| February 13, 2023 |
|--|
| Subject: Bid #: 7946-W3, Green Hill Park Community Garden / DPWP |
| ADDENDUM NO. 3 |

Project: Bid No. 7946-W3 Greenhill Park Community Garden

City of Worcester Department of Public Works and Parks

L143

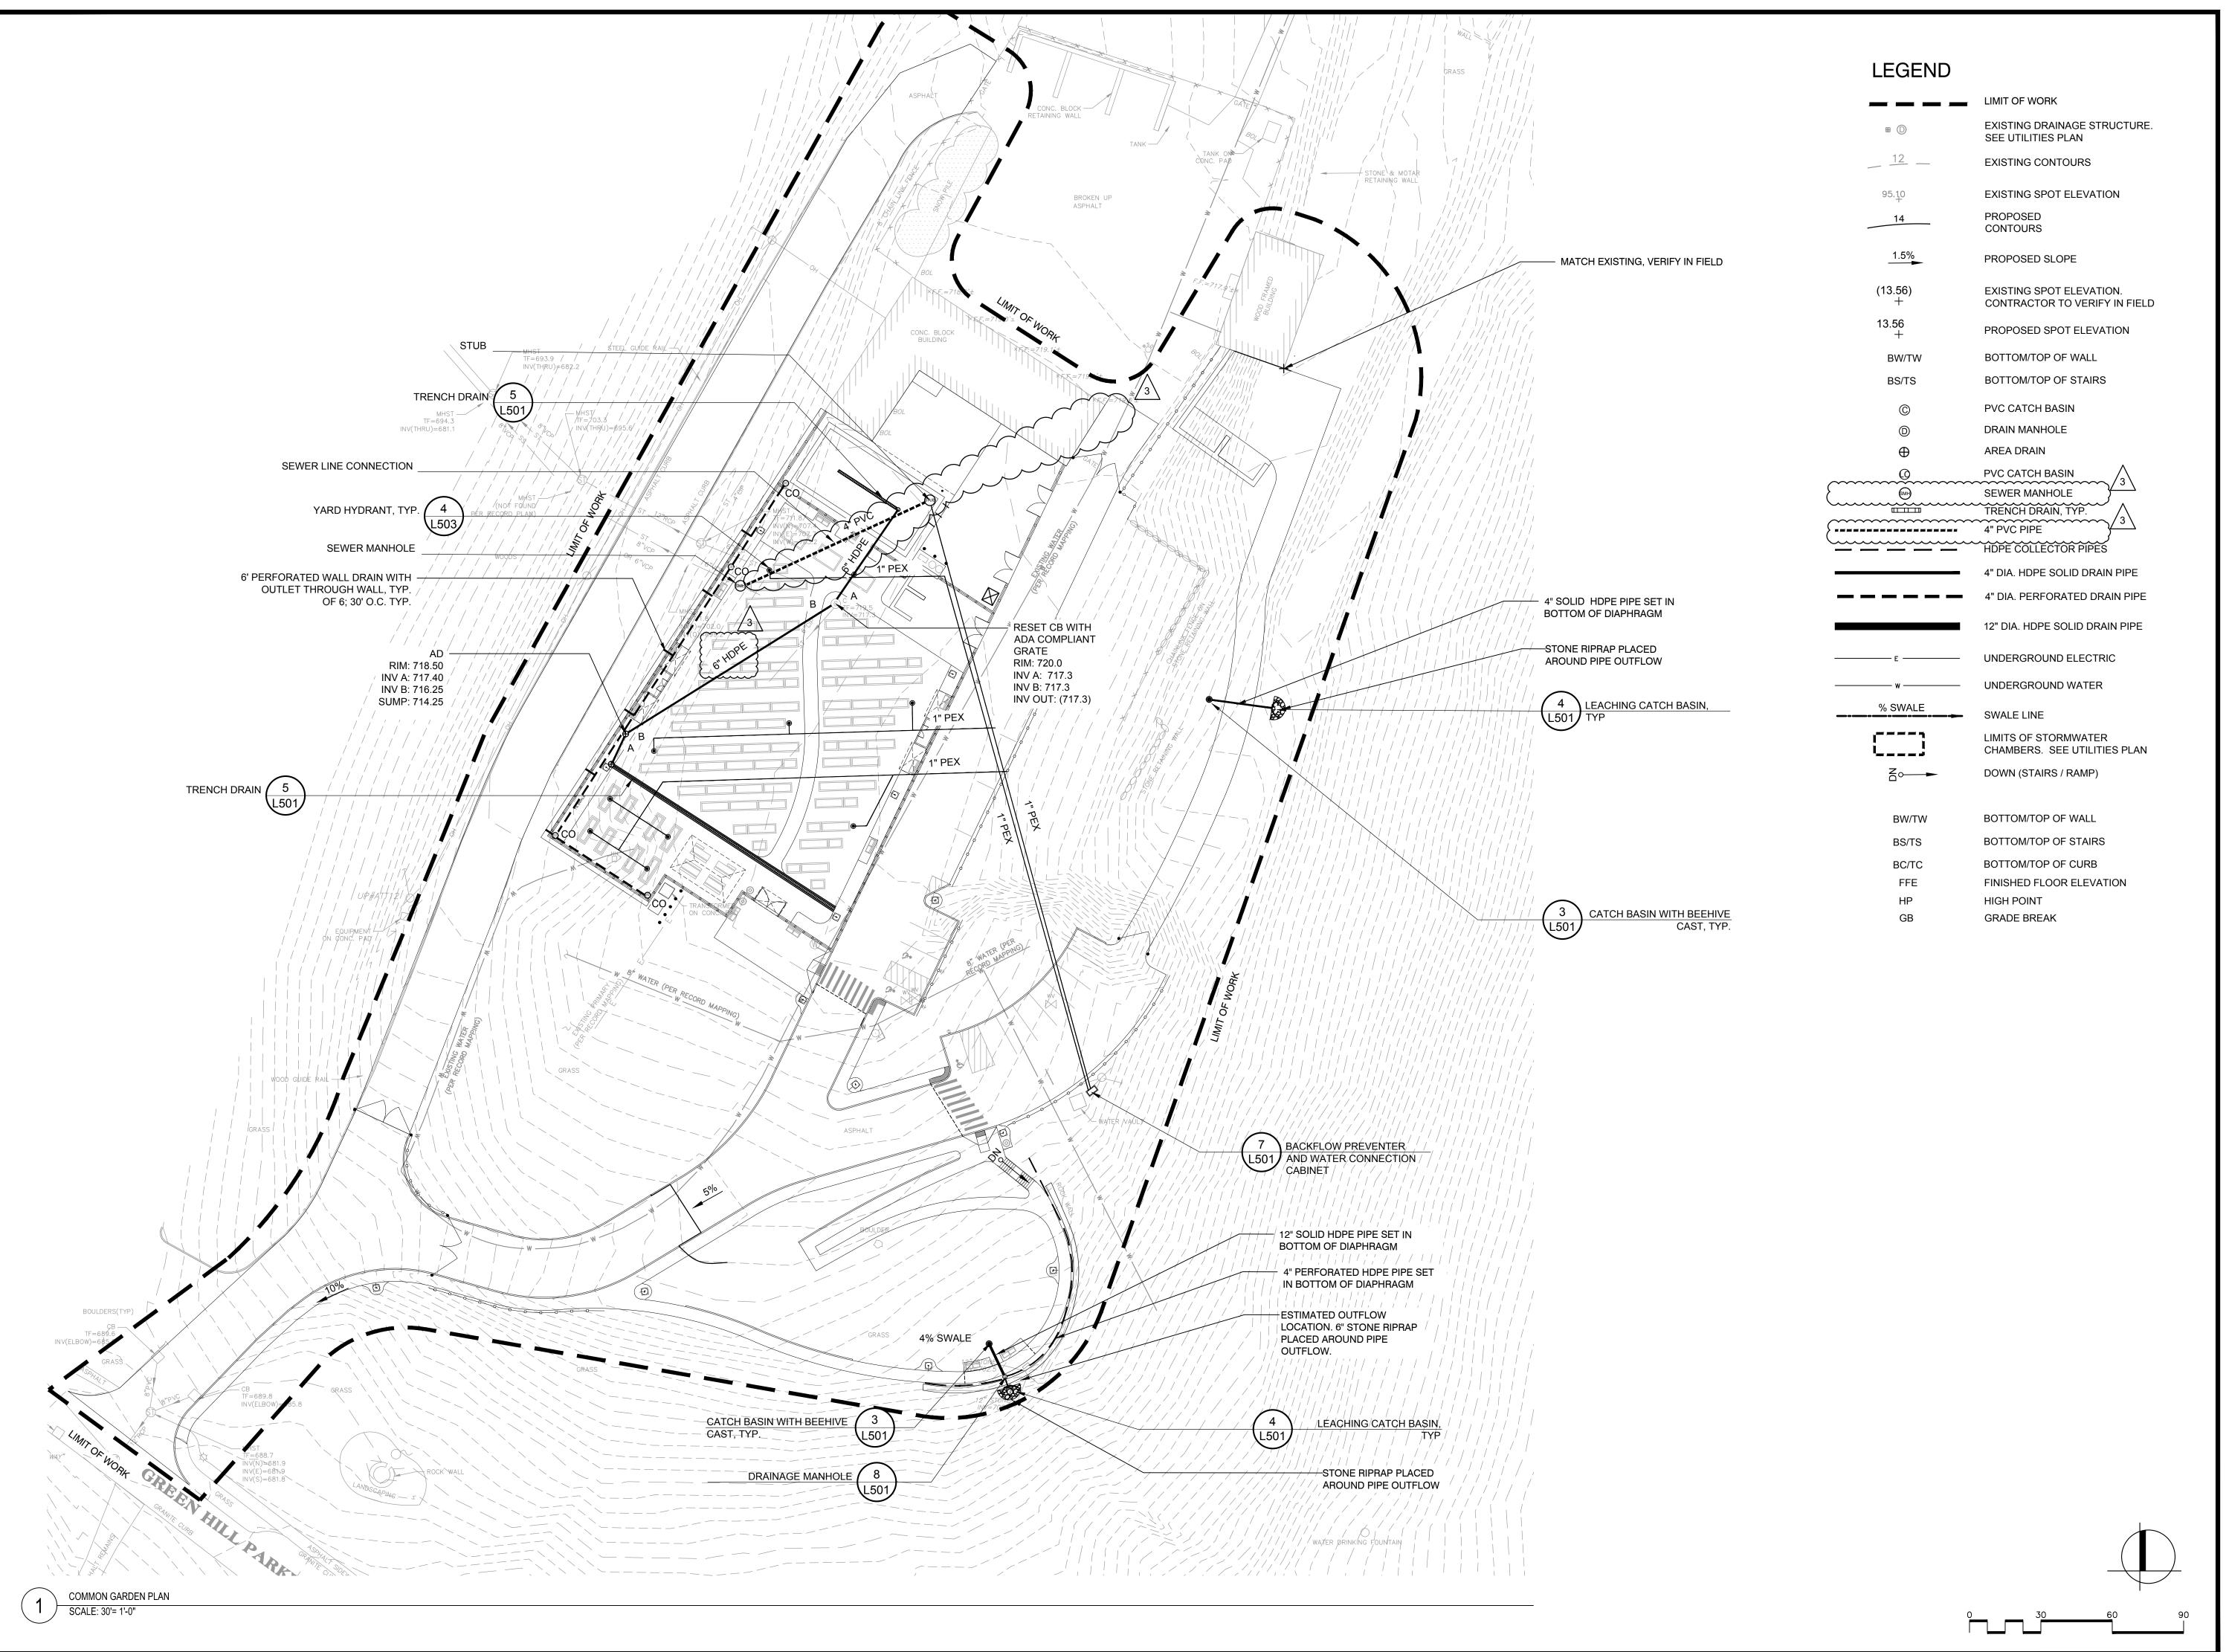
<u>Question 9:</u> On updated sheet L143, there now shows a couple sewer manholes and sewer connection. Is this proposed as there is nothing in the key and also 1 of the manholes is shown on top of the existing water. What is the connection line shown?

<u>Question 10:</u> On updated sheet L140, there shows a drain line from the trench drain in the greenhouse towards the S/SW. On the enlargement, sheet L141, it is not shown. Can you please confirm size and material.

Question 11: On updated sheets L140 & 141, where do the drain lines from the trench drains outlet?

Answer 9: Sewer manhole and connection are proposed as illustrated on attached sheet L143.

Answer 10: Per sheet L143 the pipe is 6" HDPE.

Answer 11: Per L143, the trench drains connections to the existing catch basin structure are 6" HDPE.
